GXV3350 Firmware Release Notes

FIRMWARE VERSION 1.0.3.30

GXV3350

WEB AUDIO CONTROL

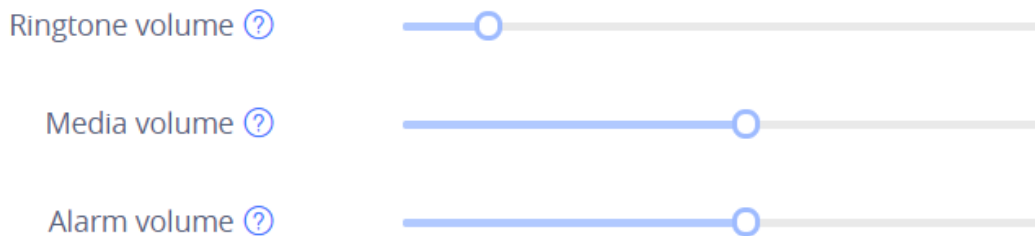
This allows users to adjust different volumes from web UI. This is in web UI -> System Settings -> Preferences -> Audio Control.

CALLEE ID DISPLAY

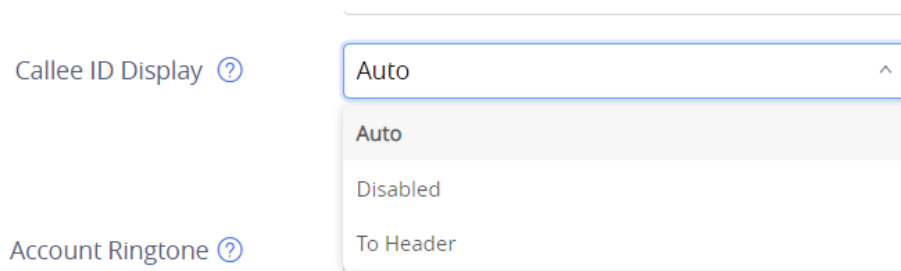
This allows users to configure the source of callee ID. If set to "Auto", if Privacy header is carried in 180 Ringing and the value is "id", "Anonymous" will be displayed on the phone; otherwise, the phone will update the callee ID in the order of P-Asserted-Identity Header, Remote-Party-ID Header and To Header. If set to "Disabled", the callee ID will be displayed as "Unavailable". If set to "To Header", the callee ID will not be updated and displayed as To Header. It is in web UI -> Account -> Call Settings.
